ADDENDUM #2

24 July 2012

RE: Eli Whitney CTHS
Additions & Renovations Project
71 Jones Road
Hamden, CT 06514
Job Nos.: Department of Construction Services – BI-RT-837 / Antinozzi Associates - 04210

FROM: ANTINOZZI ASSOCIATES, P.C.

REF. DET.: 2A/A-303 (PART OF ADDENDUM - 02)

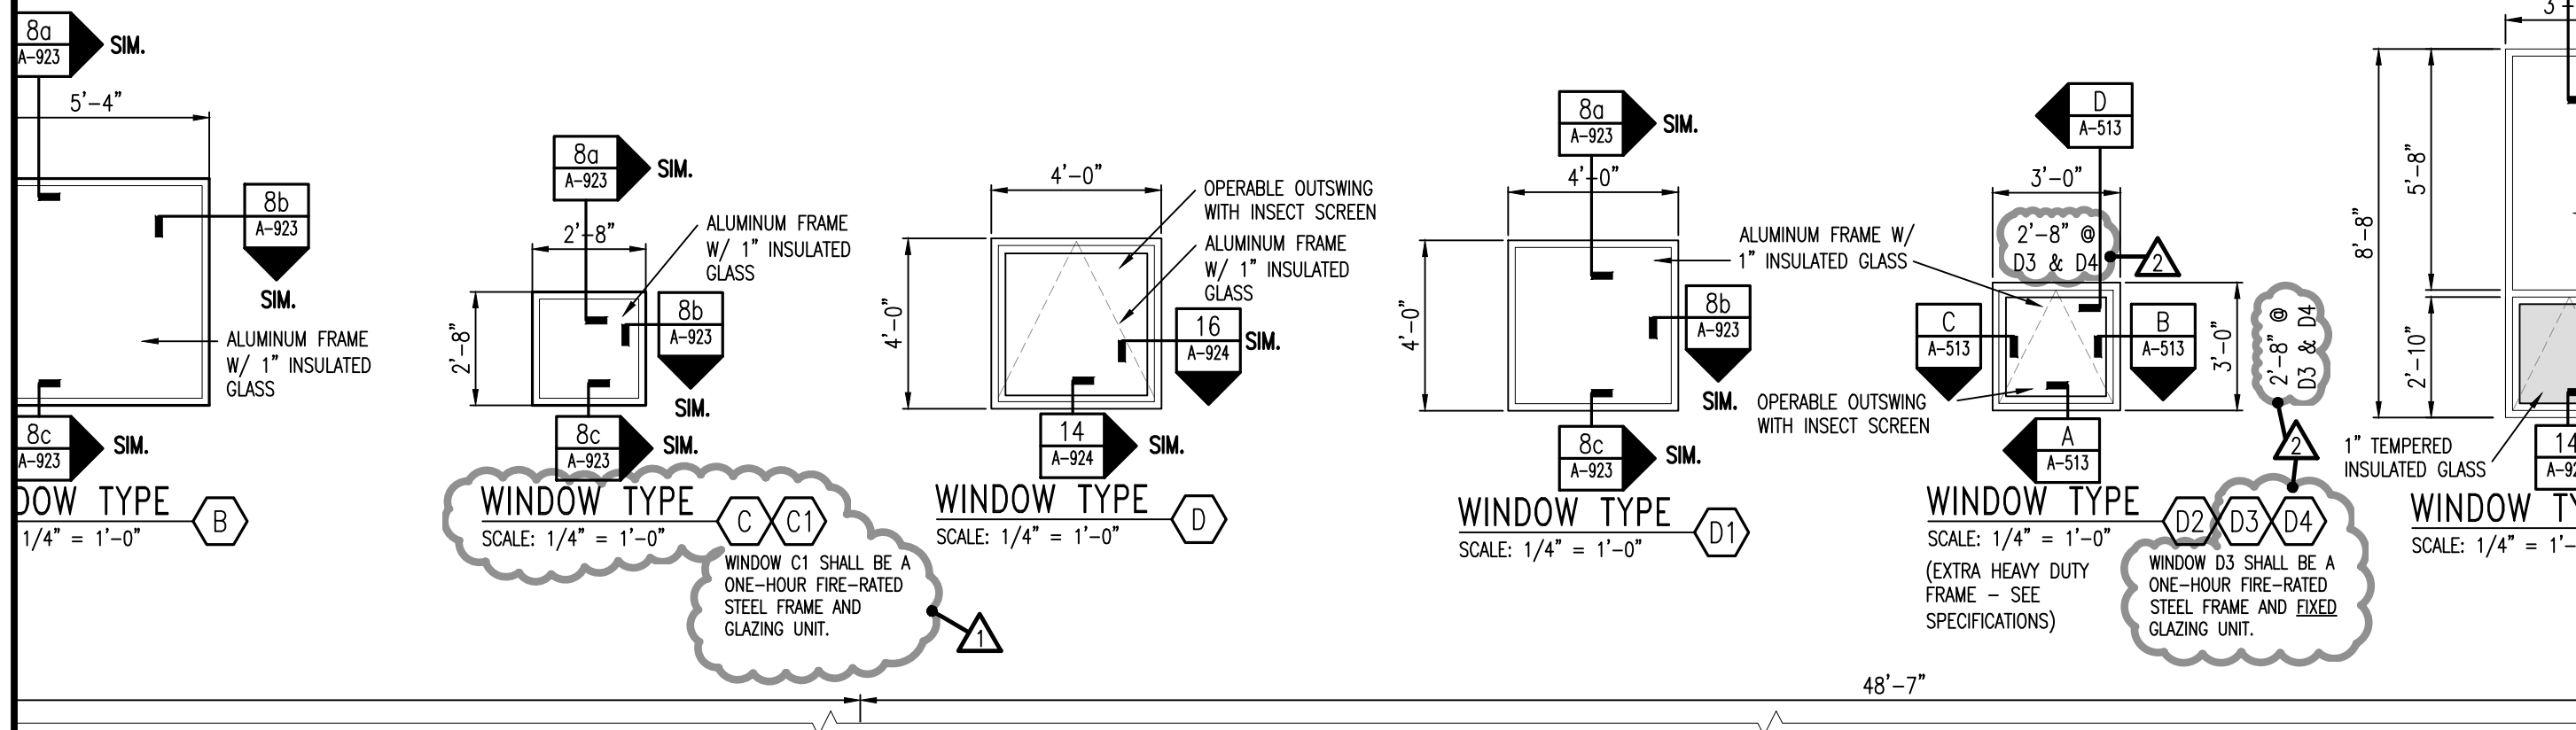
- 12) **A-303** – Exterior Elevations "B" Building
a) Revise per answer to Question "a)" from sheet A-920.
- 13) **A-540** – Building E Wall Sections
a) **Question:** *Sheet A-105.2 shows straight linear millwork at the curved exterior project north walls of room E210, E211, E212 and E213 in E-Wing at the second floor. Sheet A-105.1 does not show millwork at the curved exterior project north walls of room E127 and E132 in E-Wing at the first floor. Detail 1/A-540 and 3/A-545 depict millwork on the first floor of E-Wing at the north curved walls with a note to see floor plans for millwork; however, millwork does not appear to be shown at any of the first floor locations that apply to this detail.*

DETAIL @ GYM FOLDING PARTITION

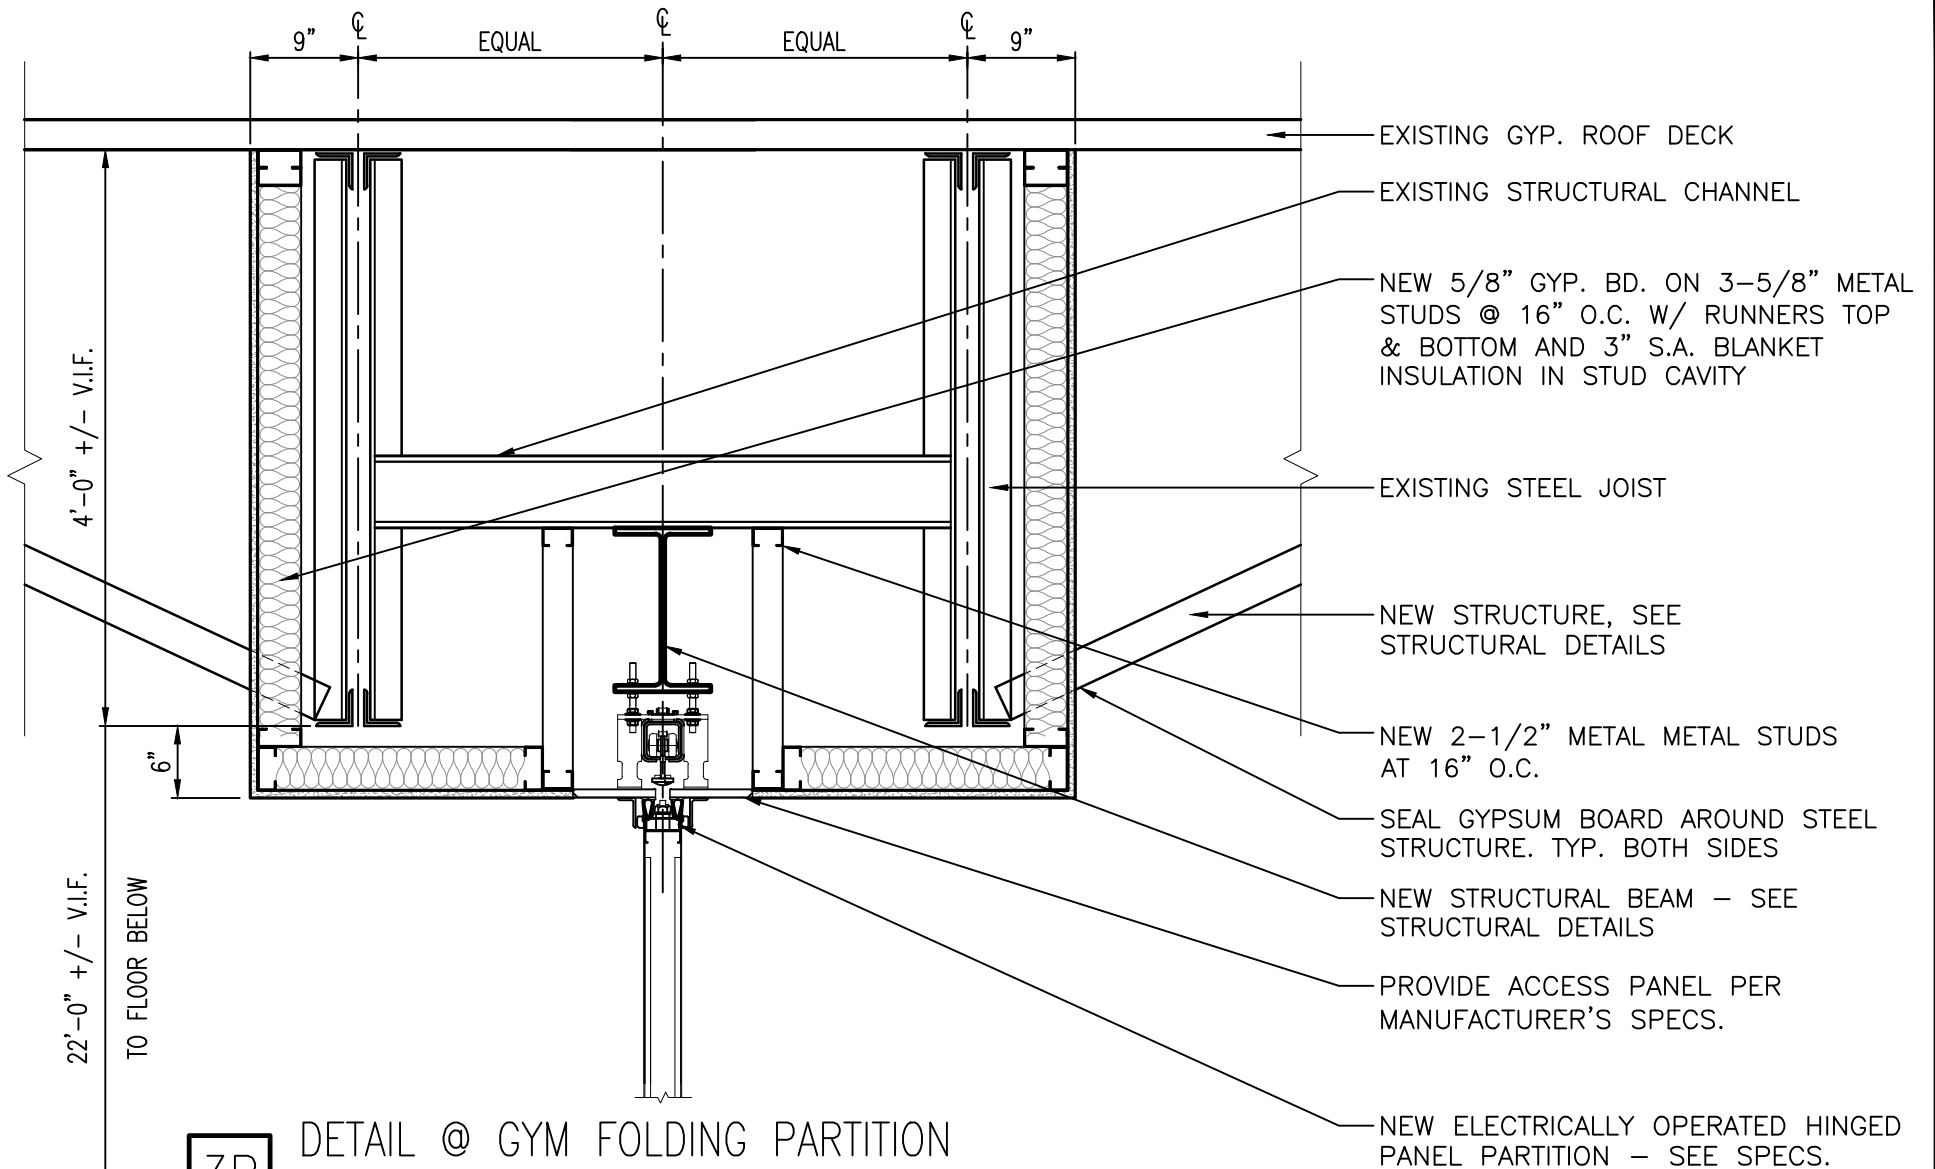
- 2) **A-103.2** – Main Level Floor Plan (Area C2)
- a) **Question:** *Sheet A-103.2 shows the location of the operable panel partition in the Gymnasium Room C150 and references detail 3/A-201.2 for the partition; however, this detail does not exist. What is the height of the folding partition in the Gymnasium Room C150? Please specify the height, provide an accurate reference from the plan and a detail or elevation for this item. Answer:* Within gym partition annotation text on sheets A-103.2 and A-203.2, delete reference to detail "3/A-201.2" and replace with detail "3B/A-201.1" (note sheet number). Add new detail 3B to sheet A-201.1 per SKA-10 dated 24 JULY 2012 attached. Also see specification section 102226.
